From: "Matthew Newton" <mnewton@hce-engineers.com.au>
Sent: 15/02/2018 16:33:34
To: "City of Gold Coast mail" <mail@goldcoast.qld.gov.au>
Cc: "MORSE Craig" <CMORSE@goldcoast.qld.gov.au>; "Bill Cuneo" <BillCuneo@spaceframe.com>; "Robert Cunningham" <RobertCunningham@spaceframe.com>
Subject: RFI Submission 84 - 160 Christensen Road South Stapylton HCE 8046 GCCC OPW201800001
Attachments: 8046-180213-LET-Council RFI.PDF, 8046-OPW RFI.PDF, 8046-180213-Re Issued For Council Approval.pdf

OPW201800001
84-160 Christensen Road South, Stapylton

The following has been prepared to address engineering items raised in Council's Information Request dated 5th February 2018. Please find attached amended engineering plans and additional information as highlighted below.

INFORMATION REQUEST

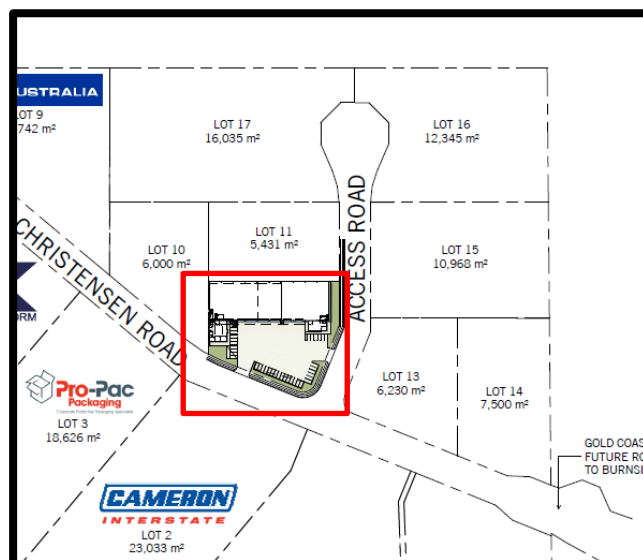
Item 2B: Council record shows that there is an existing Manhole east of the proposed connection point (End/1). Explore if the connection can be made to this manhole which will eliminate the requirement of laying the sewer across the Christensen Road South.

Response: Whilst the sewer to the east could be utilised to service the development it is proposed to construct the new sewer per the submitted design for the following reason. The existing parcel of land that the new industrial building is to be built on will be subdivided as shown below.

The sewer to the east will be located within future Lot 10 as identified above. The new sewer across Christensen Road South will be on an alignment to suit the new road identified as Access Road above and as shown on the design drawings and provide the proposed development with a sewer connection.

Furthermore, an Energex transformer is proposed to be located in the north eastern corner near the existing sewer manhole. This limits the opportunity to extend a sewer PC from the existing manhole, as sewers cannot be located under transformers.

As a result we propose to leave the sewer design per the submitted drawings.

Designed MN	Drawn MN	Date 13.12.17
Approved 	Scale AS SHOWN	
Drawing No. 8046-S01		Rev. C

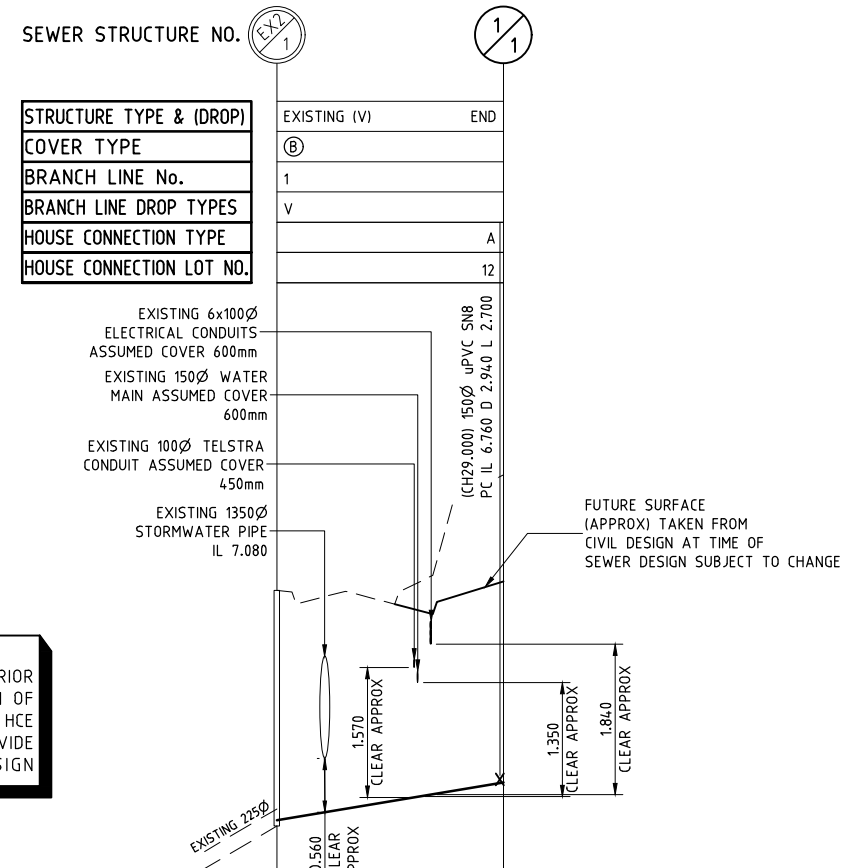
- a Council record shows that there is no rising main in the vicinity of the work area as shown in the drawing. Amend the drawings accordingly.
- b Council record shows that there is an existing Manhole east of the proposed connection point (End/1). Explore if the connection can be made to this manhole which will eliminate the requirement of laying the sewer across the Christensen Road South.
- c Update Live Sewer Works Table which shows the proposed invert level higher than the surface level.

Response: The rising main has been removed from the drawings.

GOLD COAST WATER AND CONTRACTOR LIVE SEWER WORK

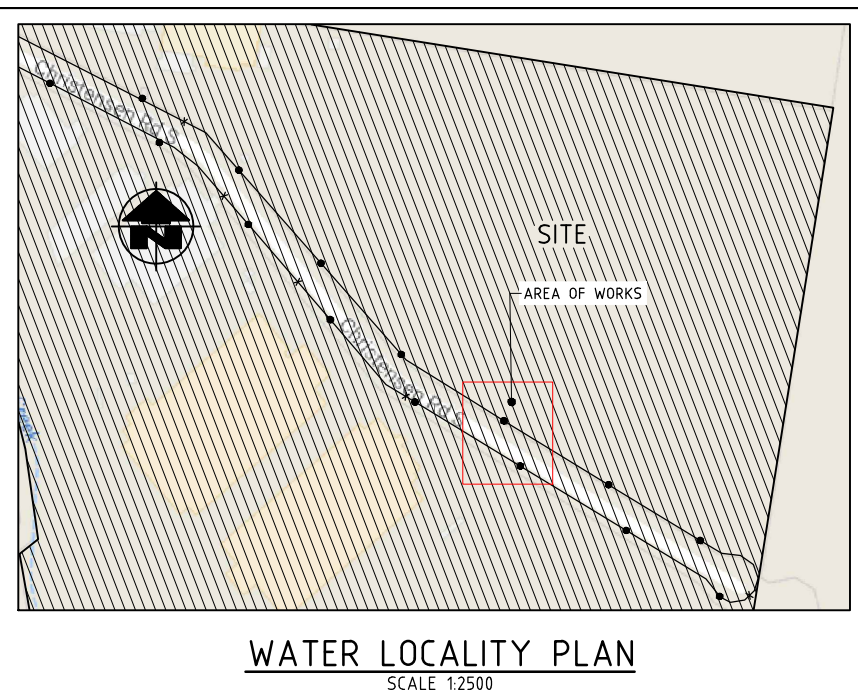
Item 2C: Update Live Sewer Works Table which shows the proposed invert level higher than the surface level.

Response: The sewer live works table has been amended.
